WATERSHED PROTECTION DEPARTMENT

Project Name: Parcel # 62077

Date of Determination: October 4, 2022

Chatham County Record Number: WP-22-490

Figure 3

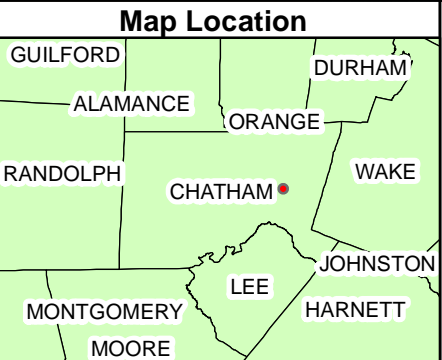
All points of origin, stream type transitions, and wetland boundaries were reviewed and agreed to in the field by all parties in attendance. Seven (7) ephemeral stream segments that were identified by Sage were removed as they did not have a well-defined channel or did not meet the 10-point requirement for an ephemeral stream.

All ephemeral stream segments will require a 30-ft buffer from the top of bank landward on both sides. All intermittent stream segments will require a 50-ft buffer from the top of bank landward on both sides. The perennial stream segment will require a 100-ft buffer from the top of bank landward on both sides.

The potential wetlands identified by Sage have not been confirmed by the US Army Corps of Engineers. Once the USACE confirmation is received the 50-ft riparian buffers will be required from the flagged wetland boundaries as confirmed by the USACE.
